INNER WEST COUNCIL

DEVELOPMENT ASSESSMENT REPORT

Application No.	DAREV/2017/29
Address	1 Rayner Street, LILYFIELD NSW 2040
Proposal	Review of Determination of D/2017/191. Consent is sought for the demolition of existing dwelling and associated structures on the site and the construction of a part 2/part 3 storey building for use as a 10 room boarding house, accommodating 19 lodgers with associated vehicle, motorcycle and bicycle parking and communal living room.
Date of Lodgement	23 October 2017
Applicant	Injaid Pty Ltd
Owner	Injaid Pty Ltd
Number of Submissions	1 st Notification. 27 submissions in opposition 2 nd Notification. 16 submissions in opposition
Value of works	\$895,800
Reason for determination at Planning Panel	Number of submissions
Main Issues	<ul style="list-style-type: none"> • Bulk, Scale & Density • Design and Character • Traffic & Parking • Neighbouring Amenity • Lack of Boarding House Amenity and Regulation • Social Impact
Recommendation	Change original determination from Refusal to Approval (Deferred Commencement)

The images below indicate the refused DA and the plans subject of this review.

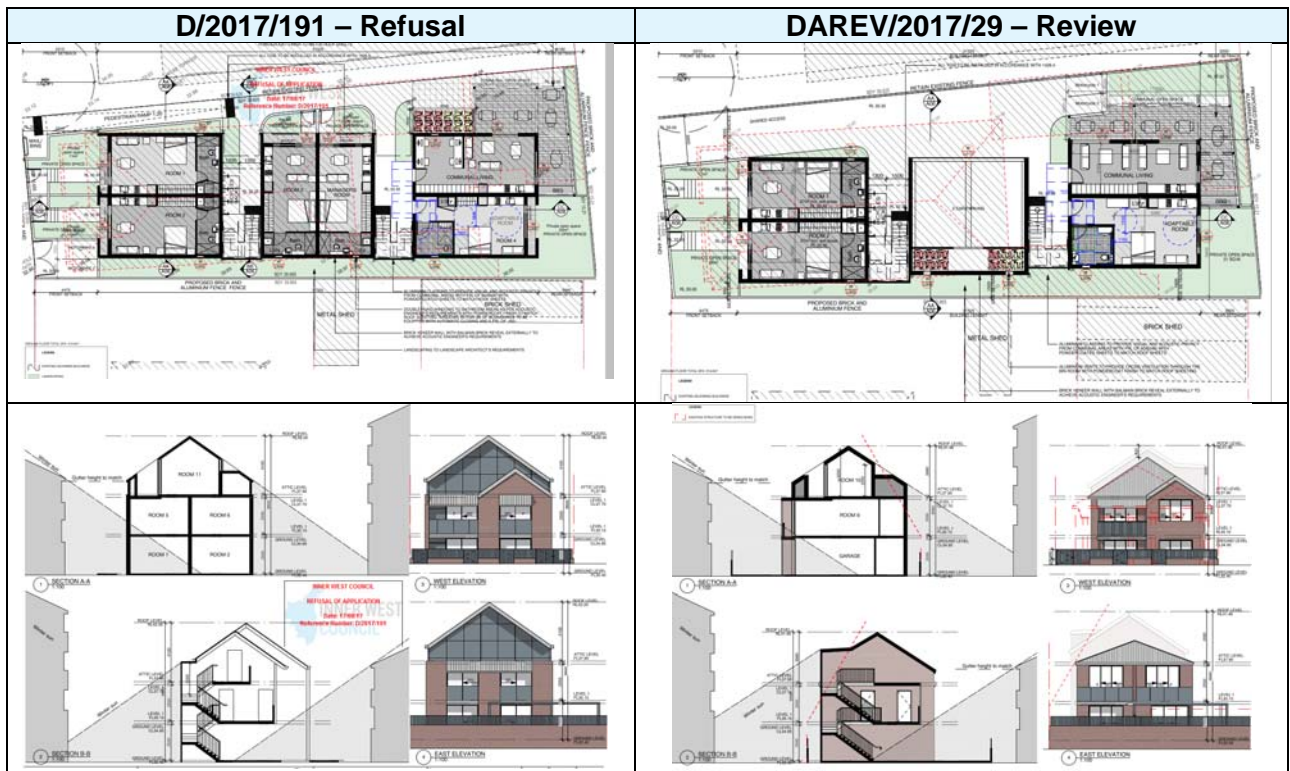
- Reduction in the number of rooms from 13 to 10
- Reduction in the height and siting of the building
- Provision of 2 on site car parking spaces

The review has amended the design of the building, with the images below indicating the refused design and the current design.

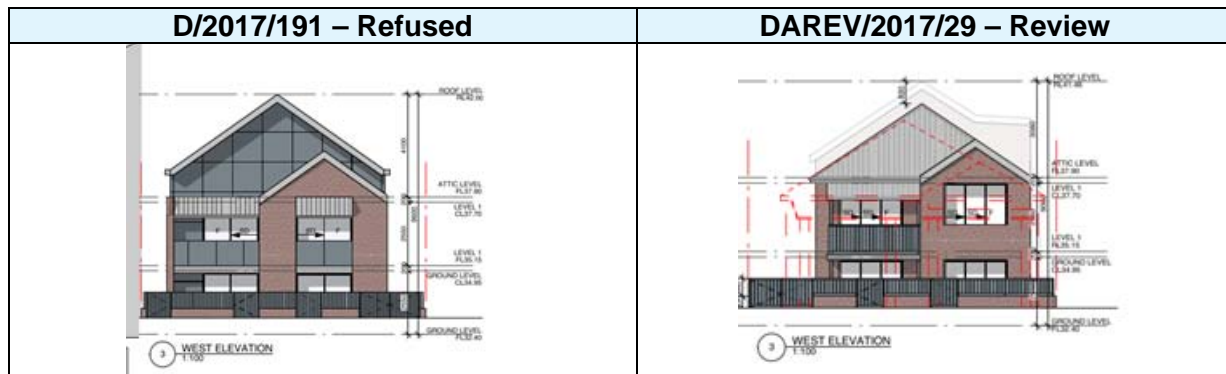
As the images indicate the building has been lowered, provided a hipped roof form and retained the gable form. The materials have also been altered, by removing the glass and provide a more 'traditional' response. The front setback is also increased which will enable a landscaped setting to Rayner Street which is considered positive.

C1.12 & C1.14 – Landscaping & Tree Management

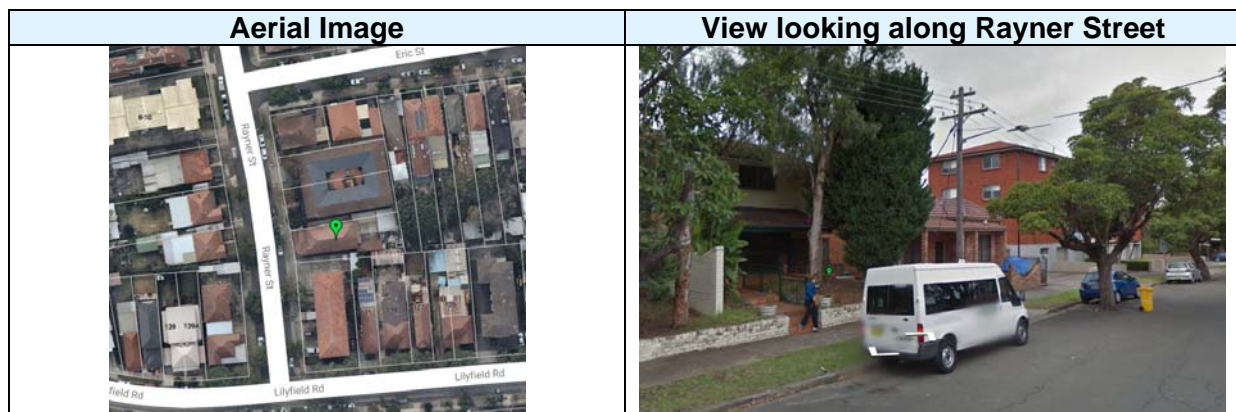
The existing site has limited vegetation and this proposal seeks to improve the site in terms of areas for vegetation and canopy trees. A Landscaped Plan was submitted with the original DA and in principle this is accepted. As a result of the amended plans lodged as part of this review a condition is recommended that a revised Landscaped Plan is submitted to reflect the amended plans with the Construction Certificate.

Tree protection measures for the *Lophostemon confertus* (Brushbox) located in the nature strip and *Cupressocyparis leylandii* (Leighton Green Conifer) located on the adjoining property are to be implemented.
